Ignition unit of ROTAX engine 912 A

Revision 1

Subject: As known from experience, inadequate ground connection could arise between stator and ignition housing on the engine type 912 A.

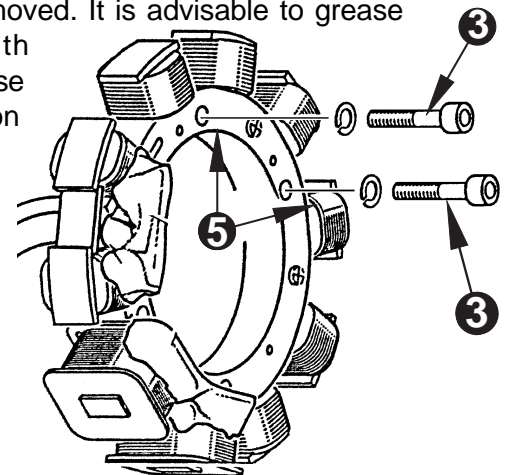
Disconnect battery. No need to withdraw magneto housing ① with magneto ring. Remove at least 2 of the 4 Allen screws ③ and lock washers for stator attachment via the openings ② in the magneto housing.

■ **ATTENTION:** Make absolutely sure that no foreign matter (lock washer or screws) will stick to the magneto ring.

Use spot-facing cutter ④ or similar tool to machine contact face ⑤ on stator for the screws ③ removed. It is advisable to grease cutting tool with Lithium-base grease to collect chips on cutter and not on magneto ring.

Refit screws M5 along with lock washer and tighten to 6 Nm. To ensure lasting ground connection, treat contact faces for screws with Lithium-base grease.
